2024 Milling and Resurfacing Project Park Avenue Public Information Meeting # 1 Summary

TUESDAY, SEPTEMBER 12, 2023, 6-7:30 PM
THE LUTHERAN CHURCH OF THE INCARNATE WORD 597 EAST AVE, 14607
AND VIA ZOOM VIDEO CONFERENCE

The City of Rochester plans to improve Park Avenue from Alexander Street to East Avenue by milling and resurfacing the street. This is a preventive maintenance project that also will include spot replacement of damaged sidewalks and curbs, new pavement markings and signs, improvements to utilities such as drainage, curb bump-outs as warranted, and enhancements to pedestrian facilities.

Typical Sections

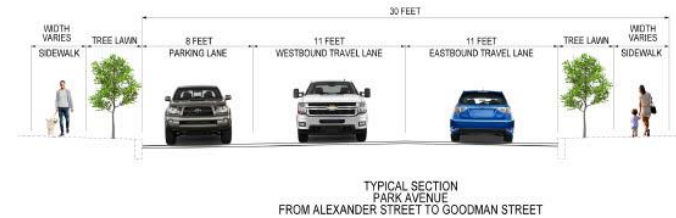
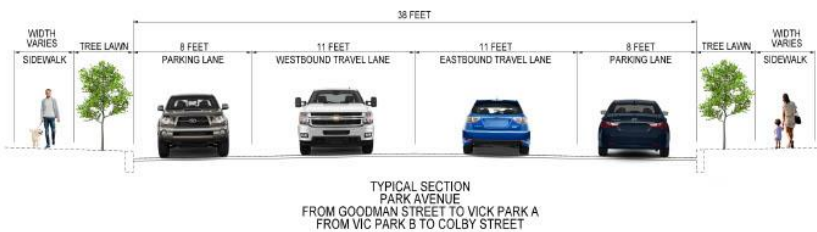
3. On entire project, why not reduce travel lanes to 10 feet opposed to 11? St. Paul and other ROC Streets use and are planned to keep 10 feet. Narrow Streets and Slow Traffic.

11. One-way configuration would allow the inclusion of bike lanes.

Response: Existing Lane widths are proposed to remain on Park Avenue. In general, there are no plans to widen existing travel lanes.)

Response: The City can consider this option as part of a longer-term planning process outside the scope of this project.
